# 2027 Disc Wheel Hub Update

The purpose of this bulletin is to notify customers of the recent changes to Webb's 2027-disc wheel hub. These changes are outlined below and will become effective immediately. If you have any questions about these changes, please contact Webb's Engineering department via email to [engineering@webbwheel.com](mailto:engineering@webbwheel.com) or call 800-633-3256.

### Oil Fill Plug

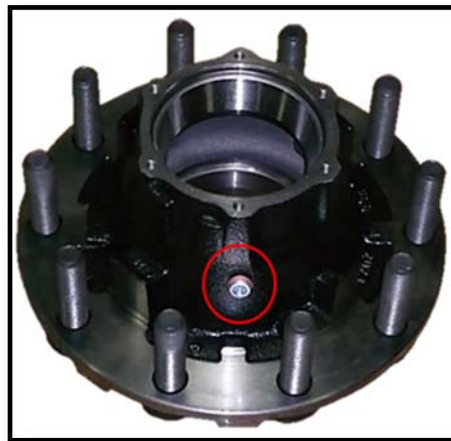
Webb Wheel's 2027-disc wheel hub will now be supplied with an oil fill plug to improve the hub's serviceability for customers that choose to lubricate their wheel end with oil lubricant. The oil fill plug will come installed and torqued to Webb's recommended specifications. All other aspects of the 2027 hub will remain the same and the addition of this feature will not affect the fit, form, or function of the hub. Furthermore, the hub will maintain its 12,500-lb. dynamic hub rating (25,000 lb. GAWR Rating). The image below shows a 2027-disc wheel hub with an oil fill plug installed.
